Florida Department of Transportation

ROADWAY DESIGN BULLETIN 11-03
DCE MEMORANDUM 02-11
(FHWA Approved: 1/12/11)

SUBJECT: OSHA RULE (29 CFR Part 1926) CRANES AND DERRICKS IN CONSTRUCTION

Example 1

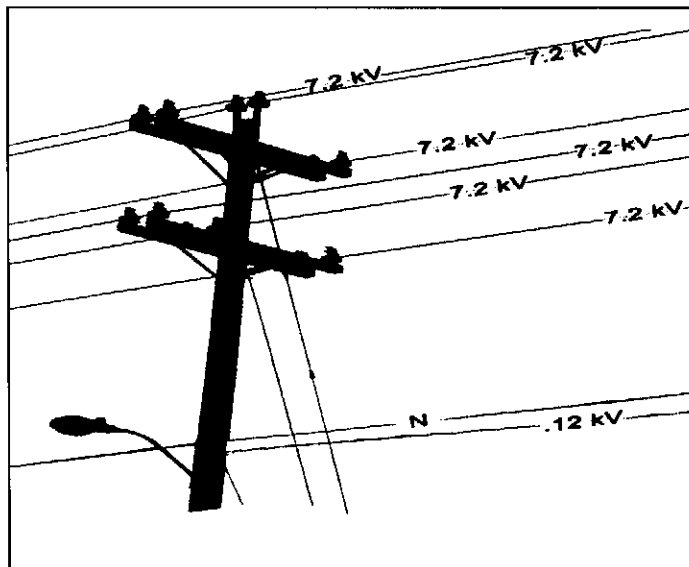
For all projects with a letting date after July 1, 2011, all overhead electrical facilities shall be labeled with the line voltage. Utility owners will be required to furnish the line voltages at the coordination phase. Multiple lines with different voltages may be found on a common pole line. For labeling purposes only one line should be shown even if there are multiple lines with different voltages. For poles with multiple lines and multiple voltages which do not exceed the 50kV threshold (see Example 1), the line should be shown in the plans as -----OE (< 50kV)-----.

Example 2

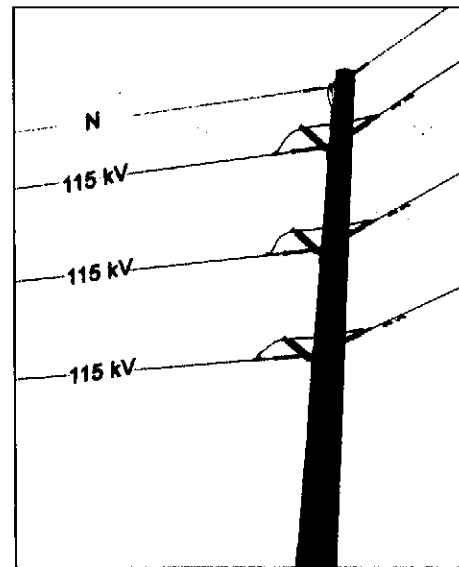
For poles with multiple lines and multiple voltages which exceed the 50kV threshold (see Example 2), the line with the greatest vertical clearance will be labeled first, separated by a slash mark, and followed by the next voltage as you move down the pole. If multiple voltages exist at

the same height, the highest voltage should be labeled. In Example 2, the line should be shown in the plans as -----OE (115kV/115kV/115kV)----- or -----OE (All lines 115kV)-----.
